# 1) Remove Collimator 3043 (12m) and replace with original beam pipe.

## **2) Remove Collimator 3076 (25m) and replace with original beam pipe.**

### **3) Move 12m Collimator (3043) to downstream LER.**

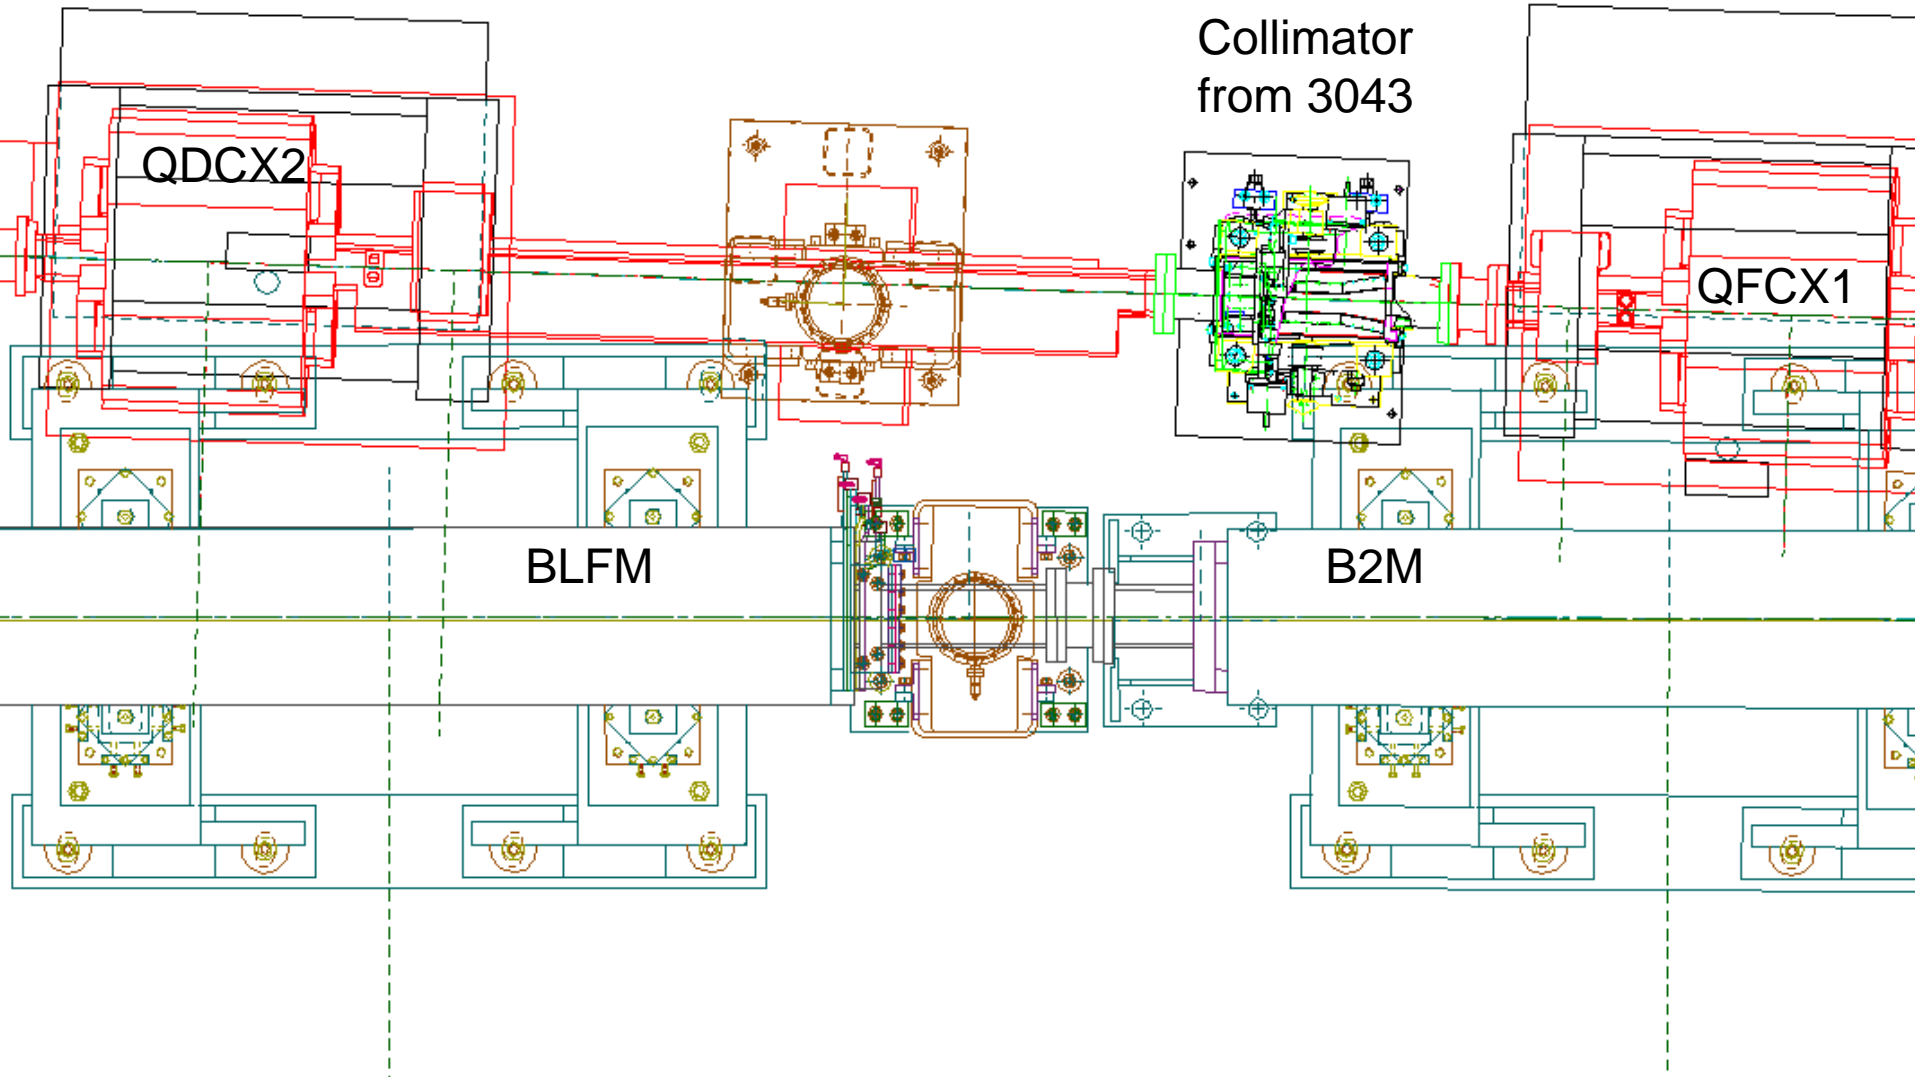
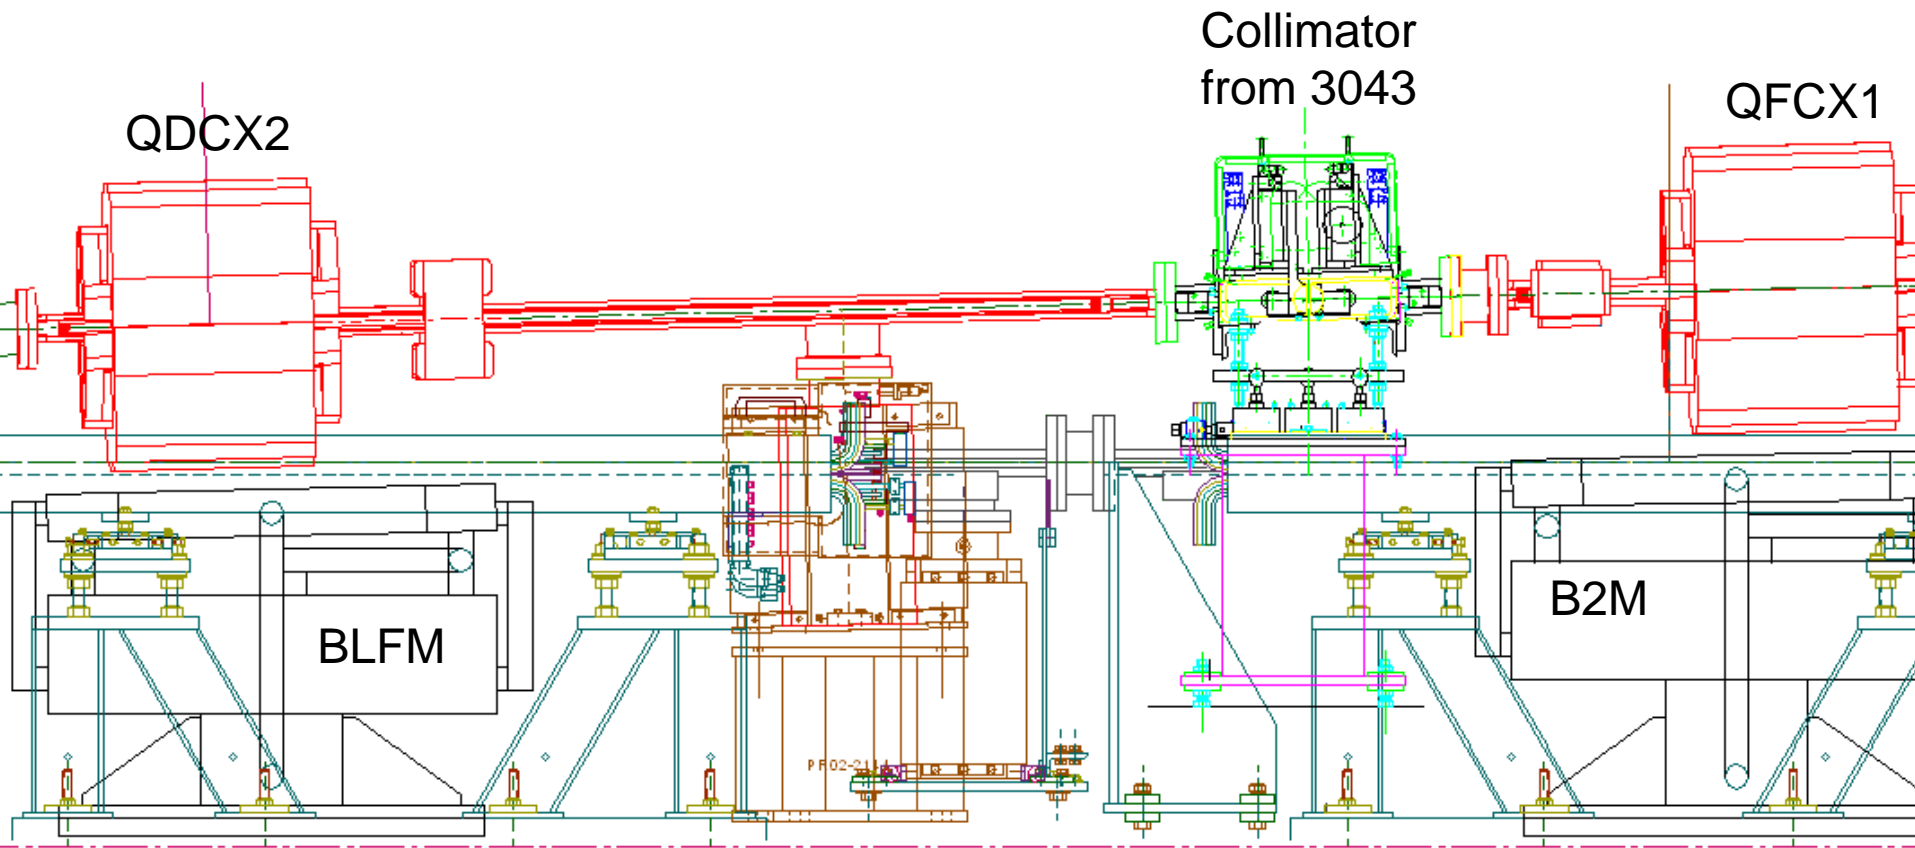
- Preliminary review:
- Collimator will fit at the 28.217m position. A new stand will be required to clear the B2 support stand and to accommodate the increased height (+11.86”).
- Requires a new drift tube with ion pump, NEG pump and possibly a new design of RF screen. Current screen is type ‘D’.
